- Rev A: Initial Release
- Rev B: Added SyncTime to Timing Generator PROM address input. Log. Dwg. p. 10.  
 Changed DevSelOK counter load control so that Dr/HdRegLd loads counter only if DrSel[0:1] is changed. Log. Dwg. p. 14.  
 Added Seek counter at b9 to produce seek Step pulse when DevOpReg is loaded with Seek bit (OutD.05). Causes SeqAdr[0:3] to be 0000 when Seek is true. Inhibits Wake-up until Step has been generated. Log. Dwg. p. 2, 3, 4, 5, & 15.  
 Replaced S189 (16 word) buffer with F93422 (256 word) buffer. Log. Dwg. p. 7 & 8.  
 Deleted Wake PROM and Counter; removed XferLate from IOAttn; deleted Flow Control Counter; added Data Wake up/down counter; added 3 wakw count to IOAttn. Log. Dwg. p. 3 & 13.  
 Deleted DRConnect signals and IDWord parity gen. Log. Dwg. p. 14 & 16.  
 Added ability to load DevBufAdrReg & MemBufAdrReg from processor. Log. Dwg. p. 6 & 7.  
 Numerous minor changes in mechanization as a result of above. Log. Dwg. p. all.

Rev Ga: generated from Rev G on 4/11/79 by CPT.

Rev Gb: 9/3/79 - CPT

Note: Splats A,B, and C are 16 pin platforms centered in the 20-pin pattern

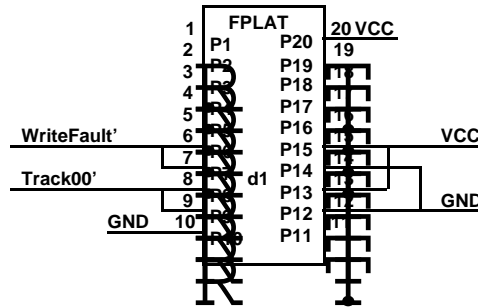
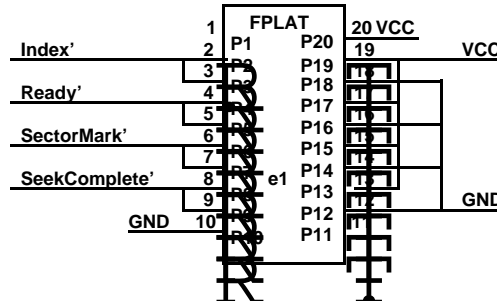
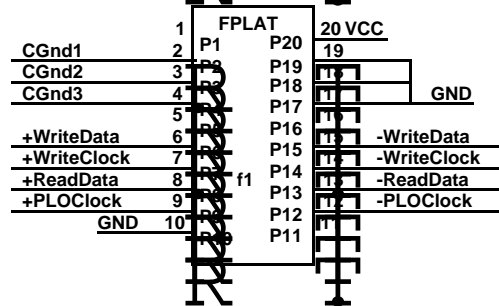
- 1) Redrew splats at d1, e1, f1 as FPLATS to avoid ROUTE trace cuts (pg 17).
- 2) Added spare positions at g3, h9, i9, e17, b10, c10 (pg 17).

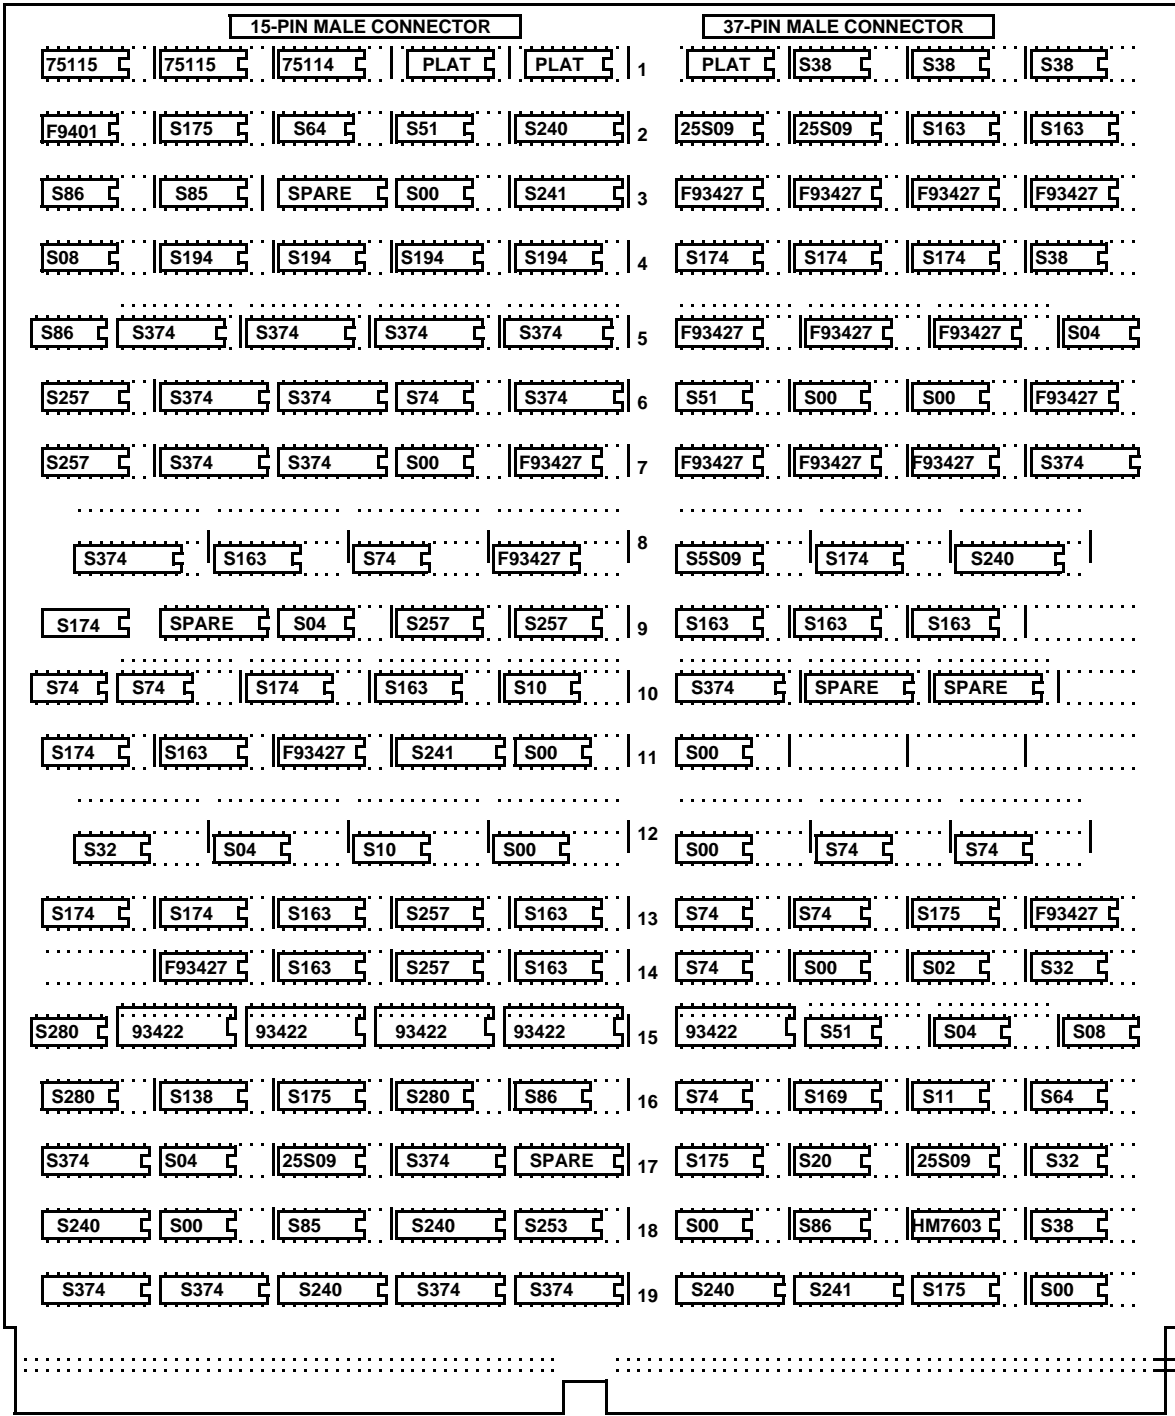
This change is a manual addition to the revision Ga MultiWire board.

1) Lift the following pins:

a15.12  
c16.9  
d10.6  
i13.10  
a13.15

2) Add an S174 IC in position i9, and wire i9.16 to Vcc.

3) Add the following wires:

a15.12 to i16.9 (DevSelOK, pg 2,16)  
c16.9 to a15.11 (RstAbrt/Err', pg 3,2)  
d10.6 to a15.9 (ClrDevOpS', pg 12)  
a15.8 to h13.1 (ClrOp', pg 4,7 - new signal name)  
a15.10 to a15.5 (IRun, pg2,12)  
i13.10 to 19.4 (Unnamed signal - was InhHdrAbrt, pg 4)  
h13.7 to i9.3 (Unnamed signal - was VerifyLabel, pg 4)  
i11.9 to i9.9 (OpRegClk', pg 4)  
i11.1 to i9.1 (RstAbrt/Err', pg 4)  
i9.5 to a13.1 (InhHdrAbrt, pg 4,12)  
i9.2 to a13.15 (VerifyLabel, pg 4,12)
